AERONAUTICAL CHARTING FORUM
Instrument Procedures Group
Meeting 06-01 – April 18, 2006

RECOMMENDATION DOCUMENT
FAA Control # 06-01-264

Subject: Uniform Standard for use of Climb Gradients on Public IAPs

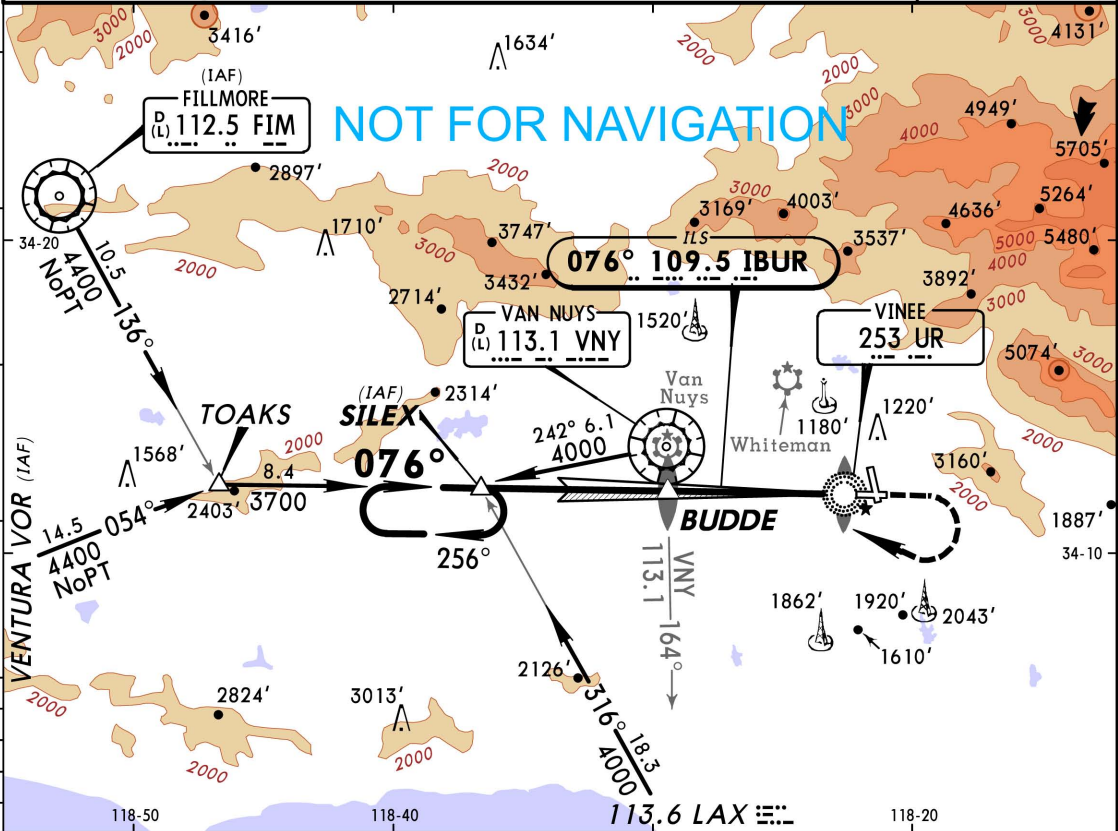
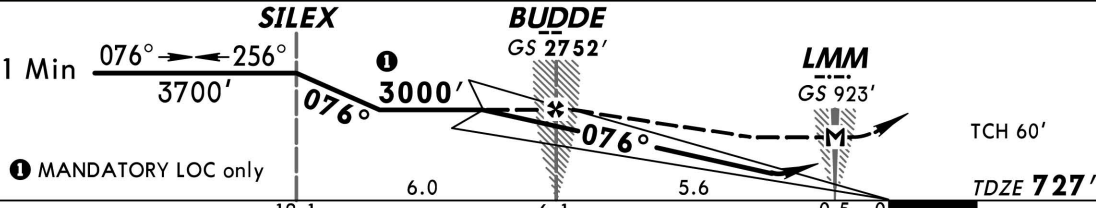
Background/Discussion: The FAA recently charted a public SIAP at San Bernardino (KSBD, ILS Runway 6) (Exhibit #1 attached) with a 280-FPNM climb gradient (CG) specified to 5,000 feet MSL (4,009 feet above TDZ elevation). The only public precedent for this is a long-standing higher-than-standard missed approach slope for the Burbank (KBUR) ILS Runway 8 (Exhibit #2 attached). KBUR is charted in a fundamentally different manner than KSBD in that rate-of-climb is charted instead of CG, and reference is made to use the KBUR LOC Runway 8 (Exhibit #3 attached) in the event the ILS' missed approach cannot be complied with. Use of rate-of-climb as a procedural data value is archaic and inconsistent with FAA national policy. Some pilots convert CG to rate-of-climb others use AFM performance data and OEM profiles to assure CG compliance. Further, some pilots use a missed approach speed that is not available on the KBUR ILS 8 SIAP rate-of-climb table.

The CG on the new KSBD SIAP was granted by a Flight Procedures Standards Waiver, which asserts that an equivalent level of safety will be achieved simply by charting the CG. The waiver states, *"The climb gradient will be published on the procedure in feet per nautical mile which will permit users to calculate their climb requirements upon other factors."* NBAA submits: (1) This does not provide an equivalent level of safety, (2) Does not comply with standard international practices (See Tarbes, France (LFBT) VOR/ILS Runway 20 [Exhibits #4 and #5 attached]), which similar such international procedures contain at least two line of minima, one predicated on standard missed approach surfaces, and the other (or others) based on steeper-than-standard missed approach surfaces; and, (3) Lacks reasonable guidance to pilots, which could be remedied by pertinent information via the AIM (preferred) or briefing attachment to the SIAP.

Recommendations: NBAA supports a uniform, consistent, and national policy for FAA implementation of missed approach climb gradients on all public SIAPs where the approach segments would support significantly lower minimums, and which are presently limited by obstacles within the missed approach segment that increase minimums in order to keep the standard MAS 40:1 clear. Where the GC would not exceed 300 feet per mile, there should be two lines of minima; one for 200 feet per mile (40:1 plus standard FAA additive), and one with lower minima predicated on the CG. Where a significant reduction in minima can be achieved with a CG greater than 300 feet per mile, but not to exceed 425 feet per mile, then 3 lines of minima should be published; i.e., 200 feet per mile, 300 feet per mile, and between 301-425 feet per mile.
